BALTIMORE COUNTY PUBLIC SCHOOLS

ADDENDUM NUMBER 2

BID NAME: NEW SCHOOL CONSTRUCTION LANSDOWNE ELEMENTARY SCHOOL
DEMOLITION OF LANSDOWNE ELEMENTARY SCHOOL

BID NUMBER: **MBU-516-17**

SK- C -23C

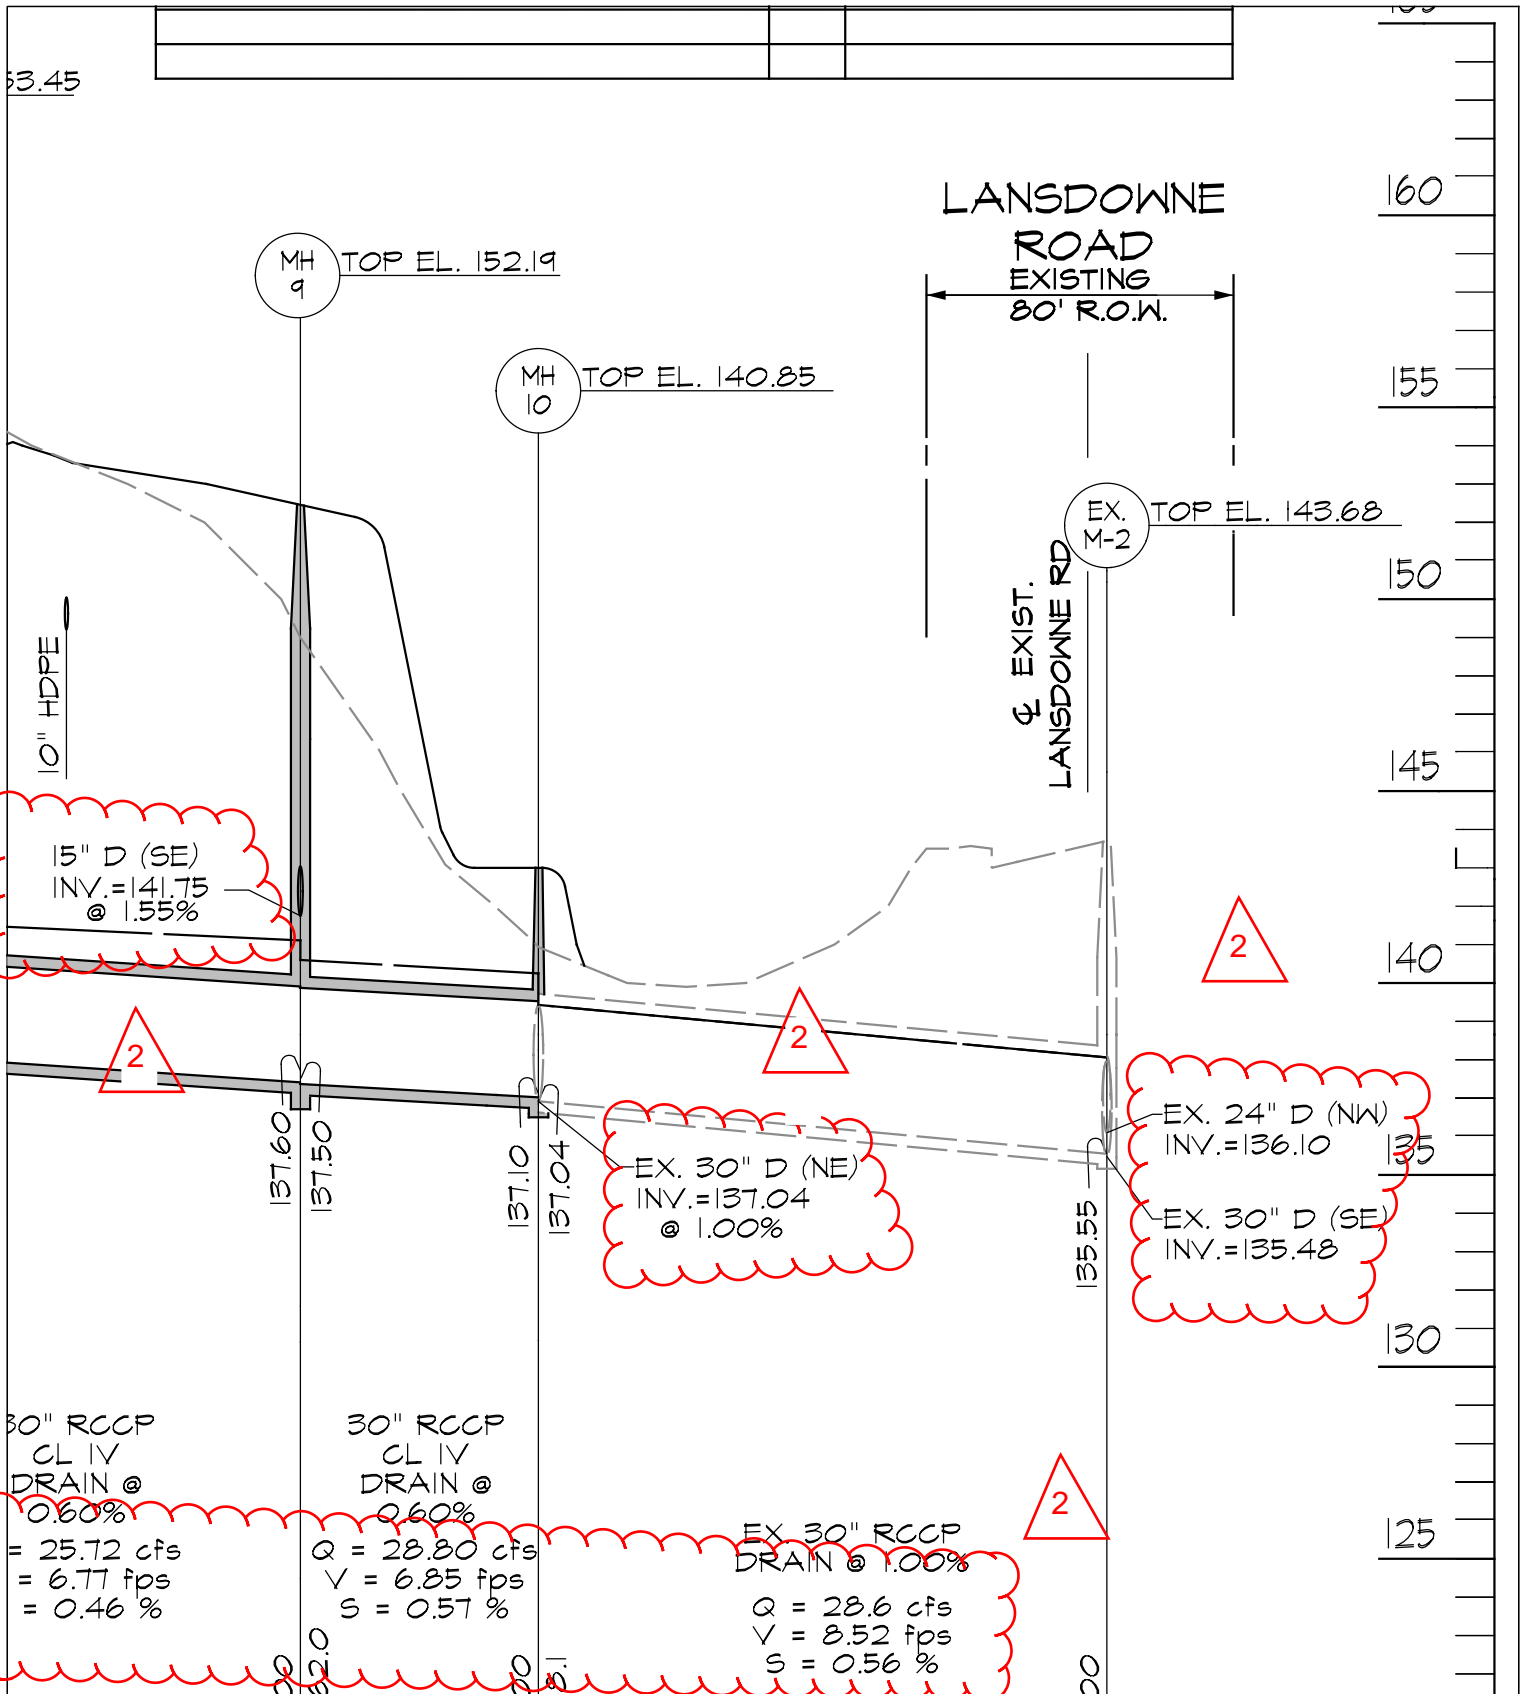
- 3.9. SHEET C-10.3, PUBLIC STORM DRAIN PLAN - 1
REVISE: Storm drain design data. See attached sketch SK-C-22.
- 3.10. SHEET C-10.4, PUBLIC STORM DRAIN PLAN – 2
REVISE: Manhole Schedule. See attached sketch SK-C-23.
ADD: Manhole 18 label. See attached sketch SK-C-23A.
REVISE: Pipe Q, V, S on the profile. See attached sketches SK-C-23A to 23D.
ADD: Pipe slope to connecting storm drain pipes on the profile. See attached sketch SK-C-23A to 23D.

SK- C -24

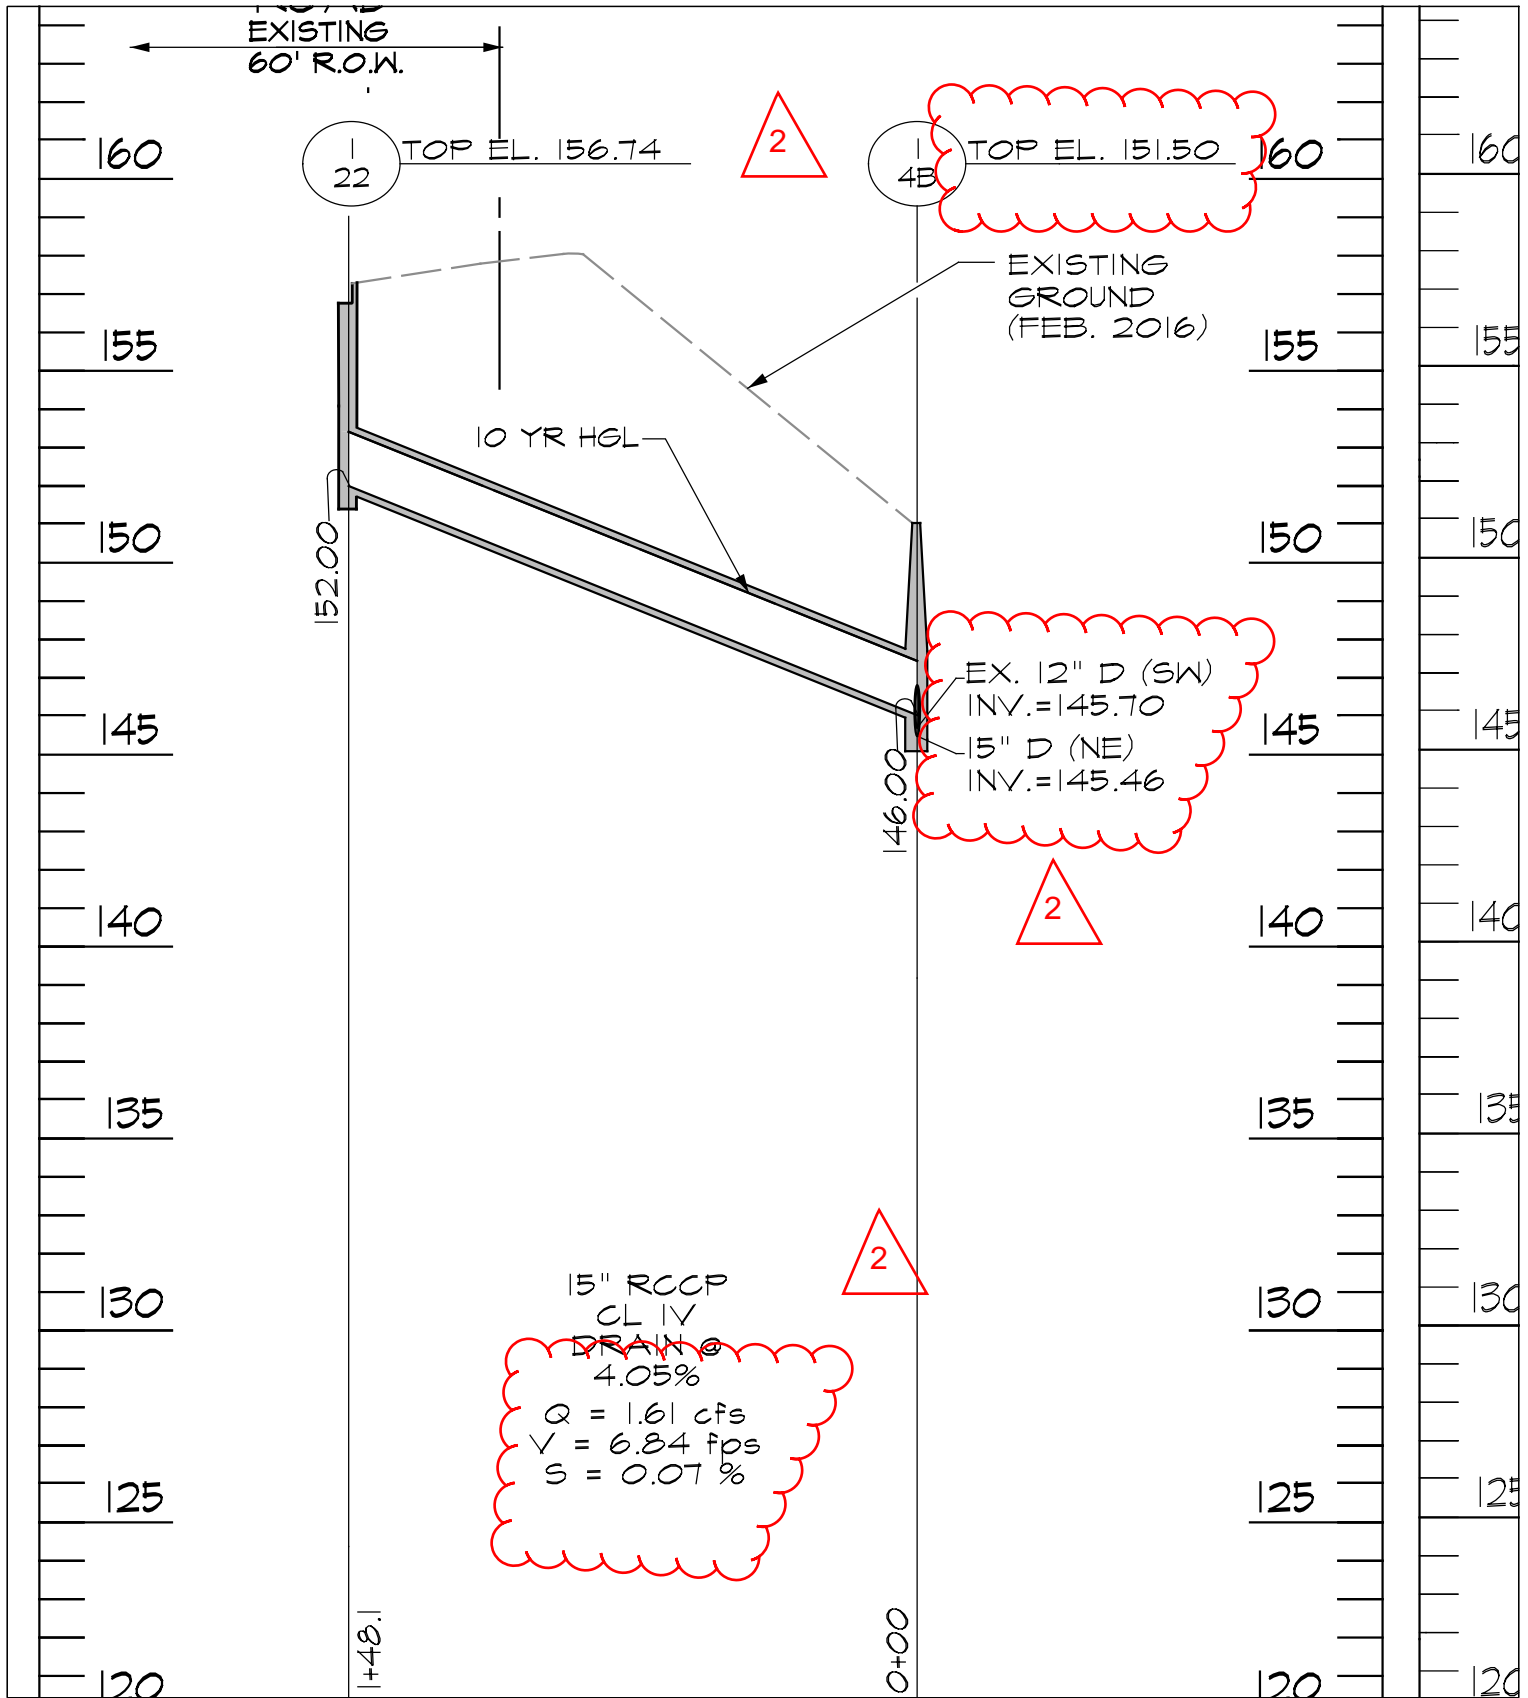
- 3.11. SHEET C-10.5, PUBLIC STORM DRAIN PLAN – 3
REVISE: Inlet Schedule. See attached sketch SK-C-24.
DELETE: Manhole Schedule. See attached sketch SK-C-24.
REVISE: Storm Drain profiles. See attached sketch SK-C-24A to 24C.
REVISE: Storm Drain layout. See attached sketch SK-C-24D.

ADD. NO. 2
SK-A-2.2

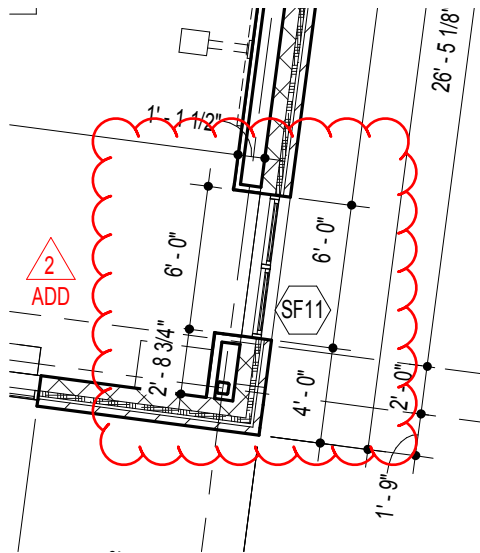
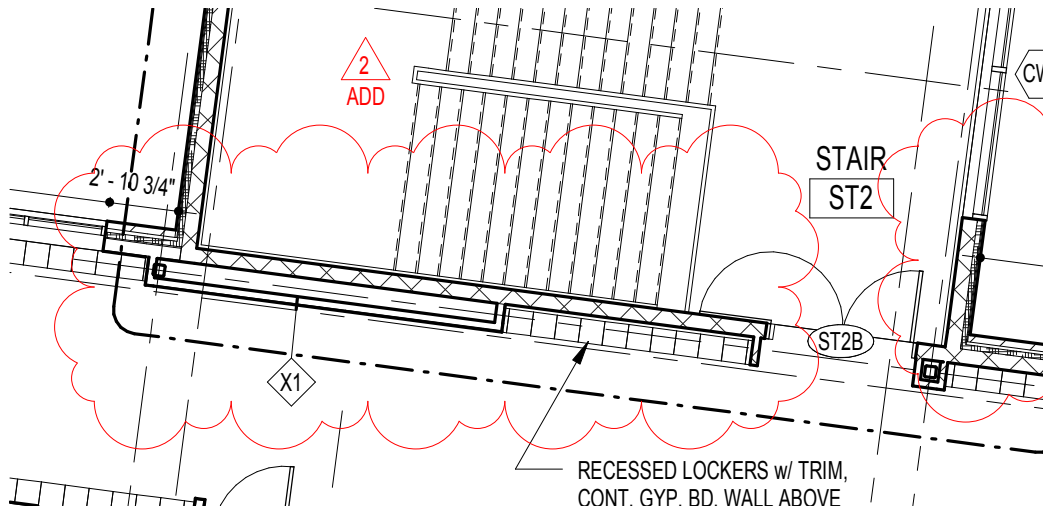
- 4.1. SHEET A-1.1B, PARTIAL FIRST FLOOR PLAN, AREA B
ADD Enclose exposed pipe column in room B131 with 1'-4" x 1'-4" CMU chase.
ADD Add wall tag, with A3 designation, to west wall of chase at the south end of the operable partition between rooms B128 and B129.
ADD Reference for J15/A-5.6 SIM to column at lines 2' and G' near door B133 and column at lines R and 11 at east end of Frame 3.
- 4.2. SHEET A-1.1C, PARTIAL FIRST FLOOR PLAN, AREA C
ADD Reference for J15/A-5.6 SIM to column at lines 17 and P.
REVISE Walls and lockers at on line C.1' on west side of stair no.2 and wall at window at south wall of room C144 per attached sketch SK-A-2.1.
REVISE Lockers at C107 per attached sketch SK-A-2.1.
REVISE Wall at window at south wall of room C127 , per attached sketch SK-A-2.2.
ADD Section reference A18/A-4.5 @ CW8 and stair 4 landing.

ADD. NO. 2
SK-A-2.4

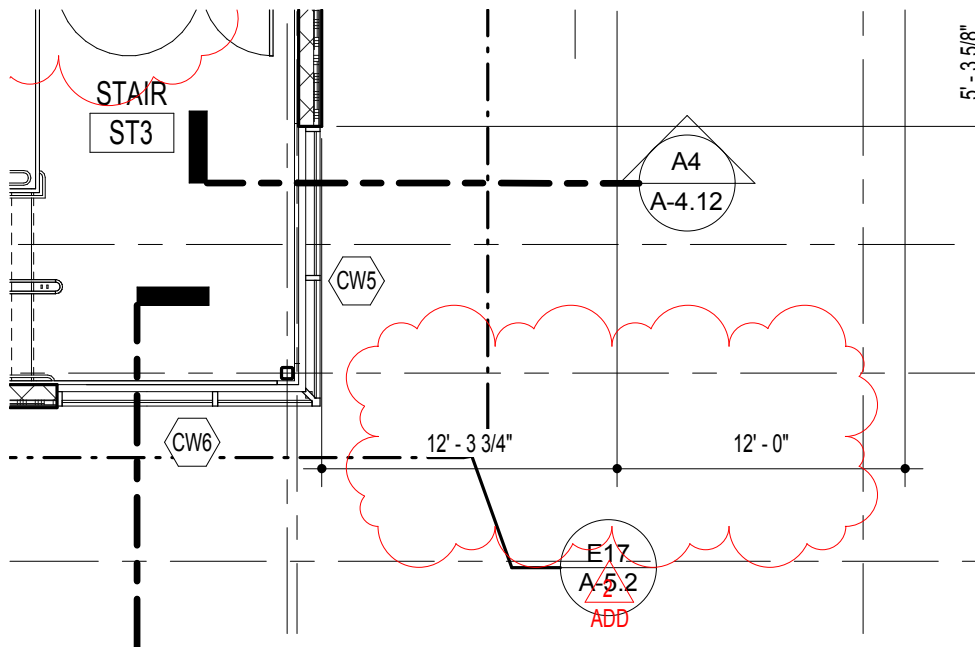
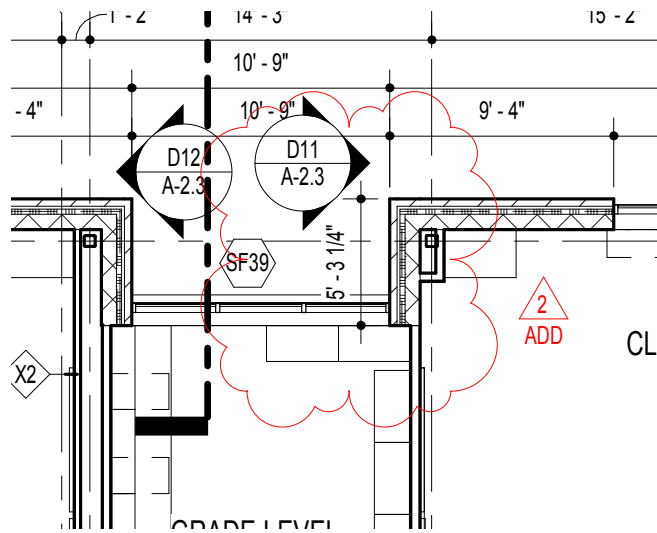
- 4.3. SHEET A-1.2C, PARTIAL SECOND FLOOR PLAN, AREA C**
ADD Section reference A18/A-4.5 @ CW8 and stair 4 landing.
ADD Section reference J11/A-4.6 @ wall between north side of stair 1 and Vestibule C10.
REVISE Walls and lockers at on line C.1' on west side of stair no.2 and wall at window at south wall of room C240 per attached sketch SK-A-2.3.
REVISE Walls and lockers on line on east side of stair no. 3 and wall at window at south wall of room C230, per attached sketch SK-A-2.6.
ADD Gypsum board surround at columns on line 22 per attached sketch SK-A-2.7.
ADD Dimensions per attached sketch SK-A-2.4 and SK-A-2.5.
ADD Lockers at locations indicated in attached sketch SK-A-2.8
